# OHIO BUILDING CODE PLAN REVIEW RECORD

## CITY OF CENTERVILLE

Centerville Washington Township Park District  
221 N. Main Street

Outlined below, please find a response to your review letter of December 14, 2005. For your convenience, our responses are numbered in the same manner as your original letter and responses are typed in bold. As discussed in our conversation of December 21 your items 1, 7, 8 and 9 deal specifically with information to be contained in the construction documents. The remaining items are included and shall be installed in accordance with the referenced section as clarified in the previous response letter.

**A-103**

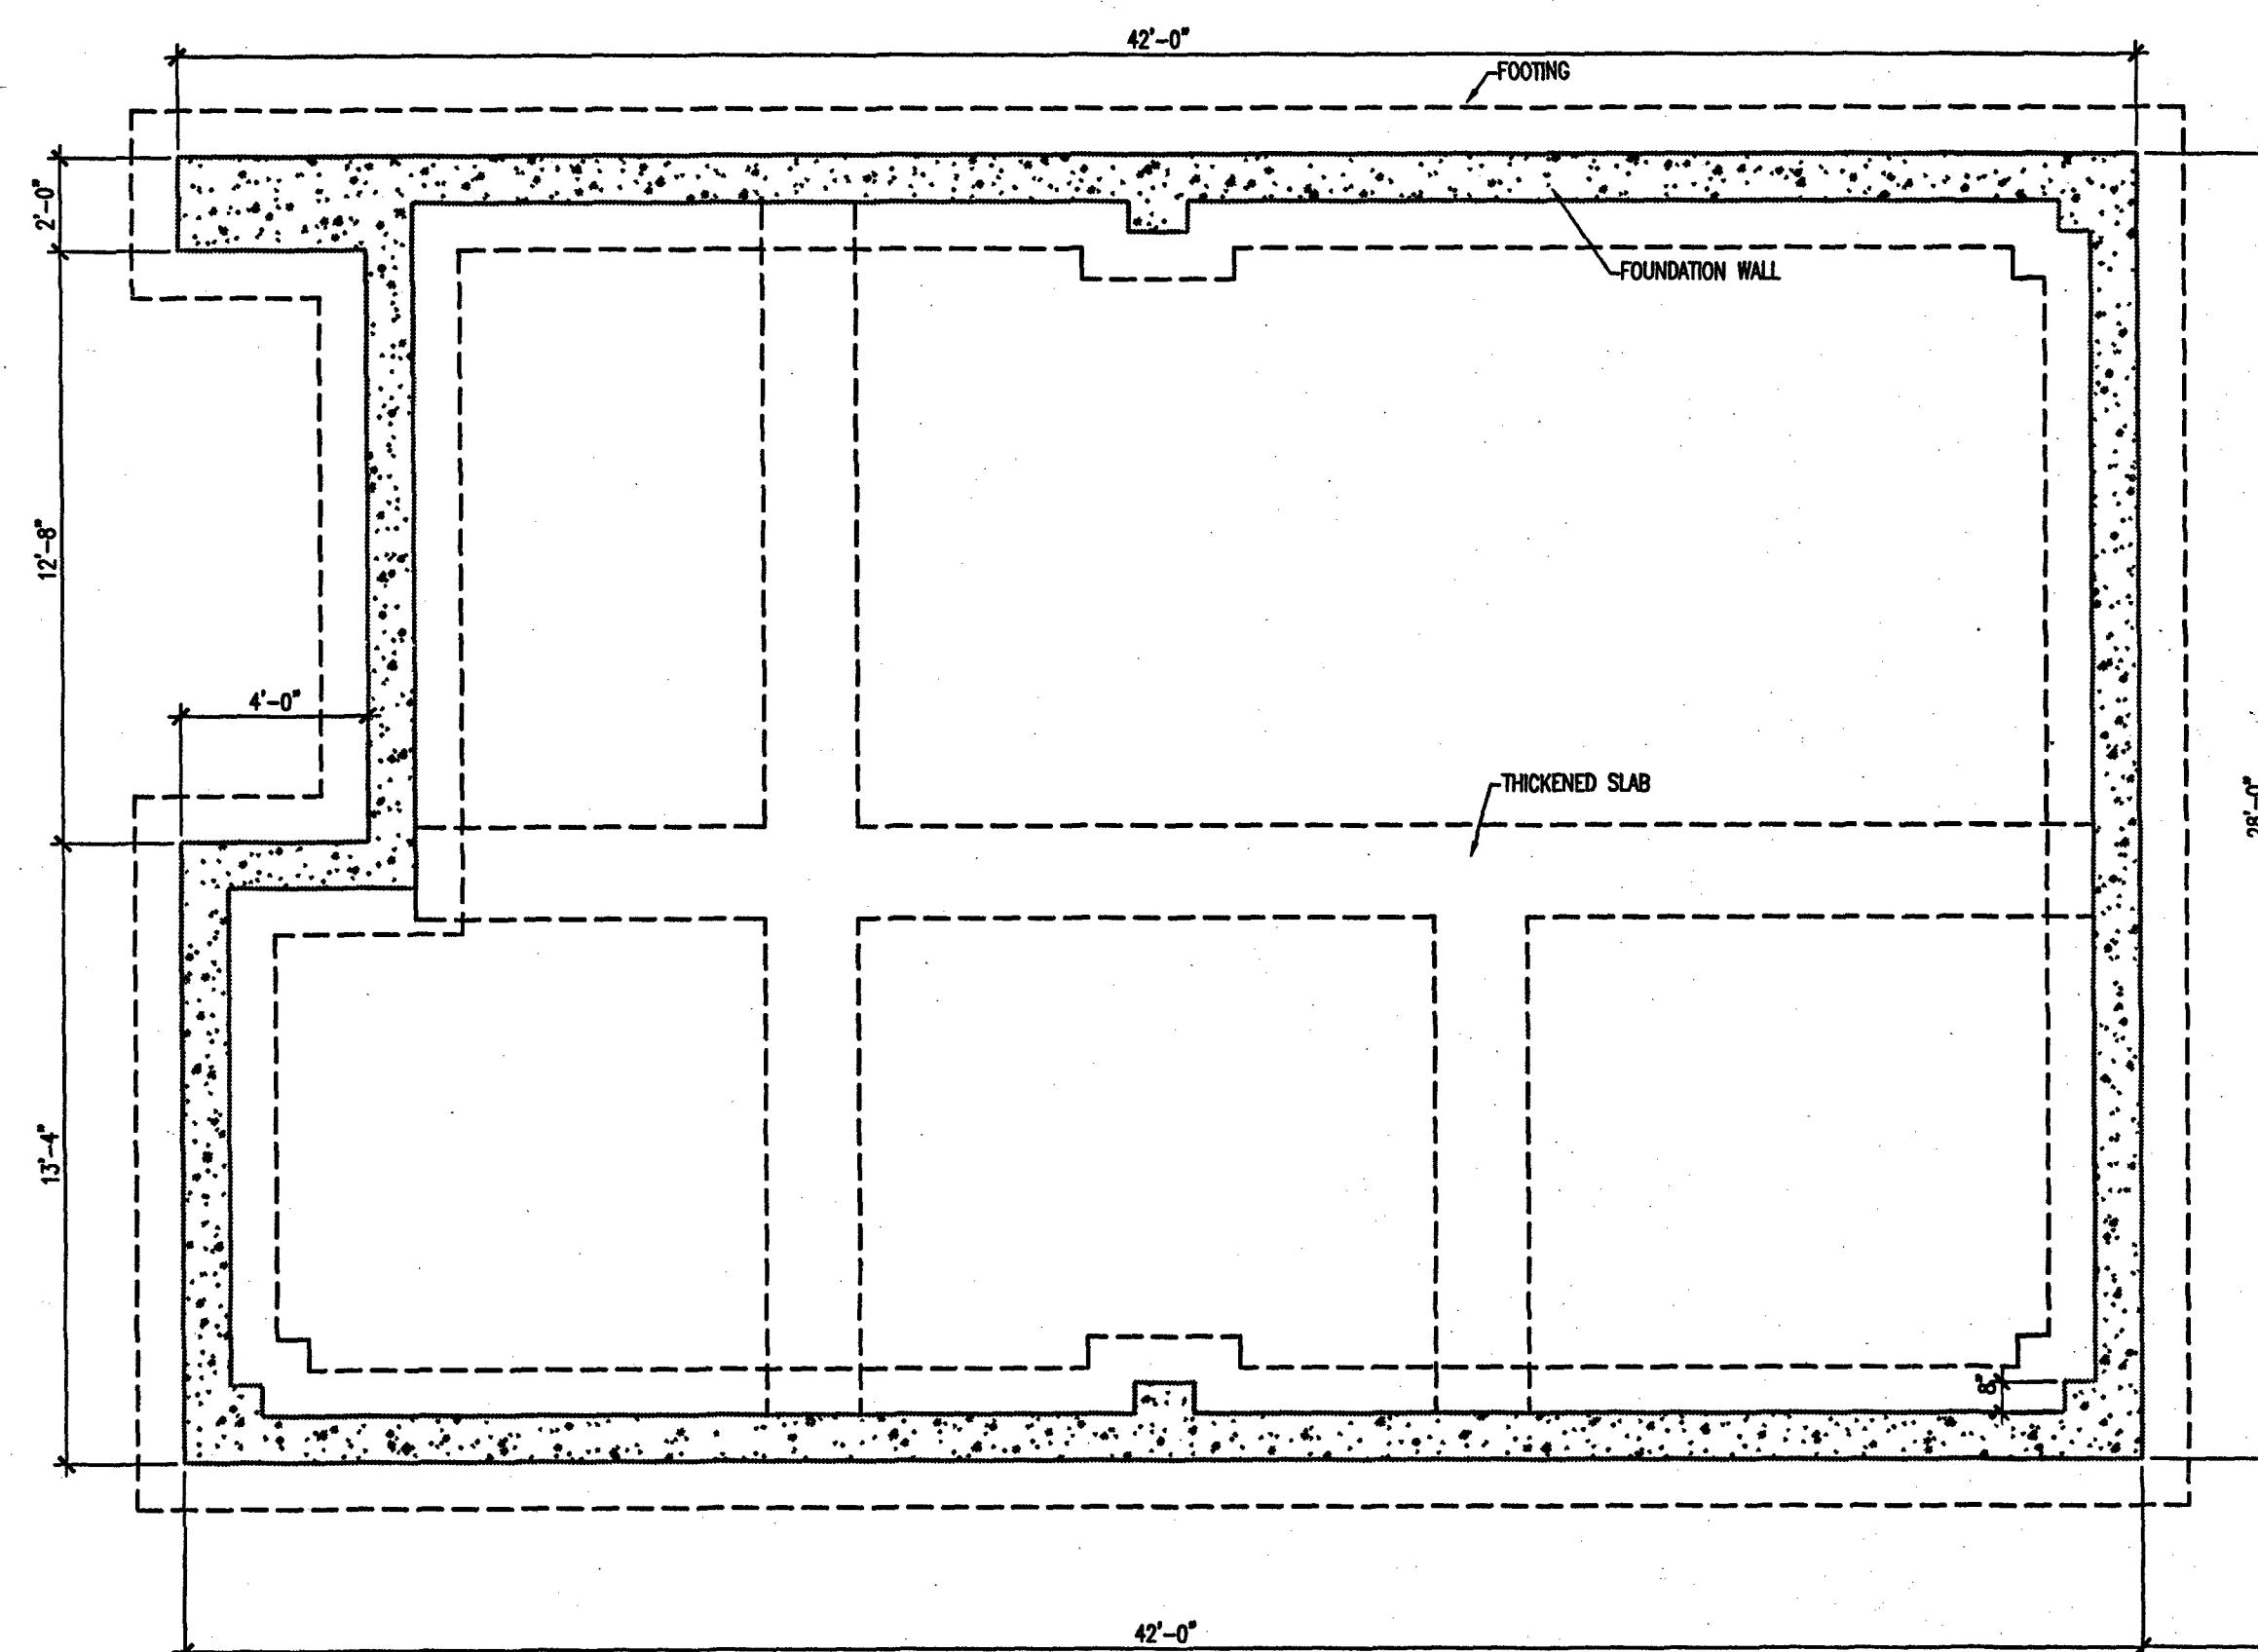
16. The construction documents shall show the size, section and relative locations of all structural members, with floor levels, column centers and offsets fully dimensioned. – Section 1603.1. No structural framing information is provided for the Activities Center.

***The Activity Center Shelter frame is a pre-engineered package. Signed sealed shop drawing will be submitted by the manufacturer. Frame locations are noted by column center lines. Sheet A-103 and Details Sheet A-501.***
